Attachment 1
Exhibit B
Summary of Hydrogeologic Conditions and Groundwater Flow Model for US
Ecology Idaho Facility

Summary of Hydrogeologic Conditions and Groundwater Flow Model

US Ecology Idaho Facility
Grand View, Idaho

January 13, 2010

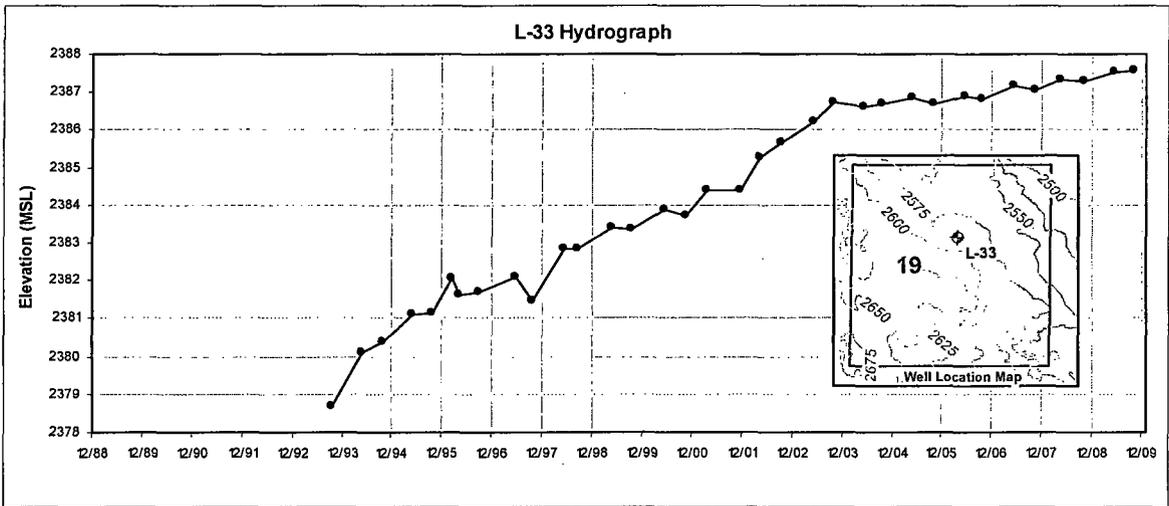
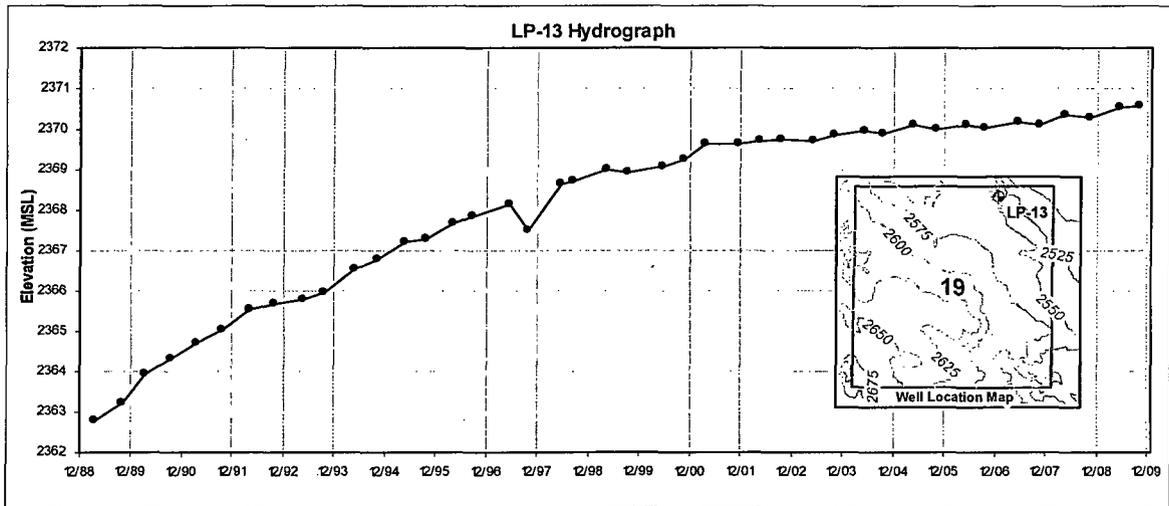
The hydrograph for Lower Aquifer well L-38 is provided to illustrate the water level response to surface loading observed in this, and several other Lower Aquifer wells. One of CCI's issues was directly related to this hydrograph. As can be seen by this hydrograph, a large spike in the water level occurred in mid-1992. This spike correlates with the stock piling of soil excavated from Cell 14. Following this sudden increase, the water levels slowly declined in a smooth curve over the next 5 years as the hydrostatic conditions in the aquifer re-equilibrated. Other, smaller, changes in surface loading occurred as additional soil stockpiles were placed, or moved in the area (1997 and 2002). Since about 2005 water levels have remained fairly constant. Other Lower Aquifer wells around L-38 and adjacent to Cell 15 show the effects of loading from the stockpiling of soils associated with cell construction. The geotechnical assessment, presented in Section 3.1 provides a more detailed analysis of the affects of soil loading on water levels.

See Section 3.1 of this response document and responses to Issues 1, 2, and 3. Furthermore, the rise in the potentiometric surface at well L-38 in 1992 was in direct response to the geologically sudden increase in surface loading as the spoils from the excavation of trench 14 were stockpiled adjacent to this well. For the next 10 years water levels slowly recovered (declined) as the aquifer reached a new equilibrium with this loading. In 2002 additional spoils were moved into the area causing another small increase with a commensurate gradual decline for about 3 years. Since 2005 water levels in this well have been approximately constant. Other Lower Aquifer wells in the vicinity of Cells 14 and 15 also show rapid water level variations apparently related stockpiling and moving of spoils and the excavating and filling of trenches. Lower Aquifer wells more distant from the construction activity do not show these variations. The author should review the concept of hydraulic soil loading and effective stress on confined aquifer systems.
